Access Compliance Report

Public Rights-of-Way

Intersection ID: 29571	Main Street: WHITEHALL_PARK_DR	Cross Street: ARCO_CORPORATE_DR	Location: NE
ADA ID: 540EA97A3E70	Ramp Type: PerpDiag	Initial Pass/Fail: Fail	Overall Compliance: No
			Severity Score: 33.75

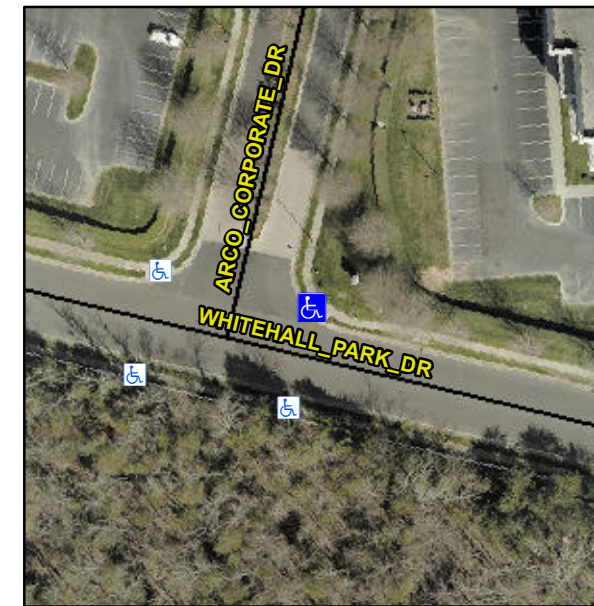
Not Found, R304.5.1, R304.2.2, R304.5.3

Compliance	Description	Data	Compliance	Description	Data
N/A	Ramp Length (in)	46.0	No	Ramp Slope (%)	8.5
No	Ramp Width (in)	42.0	No	Ramp XSlope (%)	5.9
N/A	Flare Type LT	N/A	N/A	Flare Type RT	N/A
N/A	Flare Slope LT (%)	N/A	N/A	Flare Slope RT (%)	N/A
N/A	Flare Traversable LT?	N/A	N/A	Flare Traversable RT?	N/A
N/A	Landing Length (in)	N/A	N/A	DWS Provided?	N/A
N/A	Landing Width (in)	N/A	N/A	DWS Contrast?	N/A
N/A	Landing Slope (%)	N/A	N/A	DWS Length (in)	N/A
N/A	Landing X Slope (%)	N/A	N/A	DWS Full Width?	N/A
N/A	Landing Curb? (Y/N)	N/A	N/A	DWS Offset (in)	N/A
N/A	Shared Landing?	N/A			
N/A	Gutter Ponding?	N/A	N/A	Gutter Slope (%)	N/A
N/A	Gutter Lip Ht (in)	N/A	N/A	Gutter X Slope (%)	N/A
N/A	Painted X Walk1?	No	N/A	Painted X Walk2?	No
	X Walk 1 Direction	To NW		X Walk 2 Direction	To SW
N/A	X Walk 1 Width (in)	N/A	N/A	X Walk 2 Width (in)	N/A
	X Walk 1 Slope (%)	1.1		X Walk 2 Slope (%)	3.4
	X Walk 1 X Slope (%)	7.5		X Walk 2 X Slope (%)	0.5

Remove & Replace Curb Ramp With Two New Directional Ramps or Equivalent.
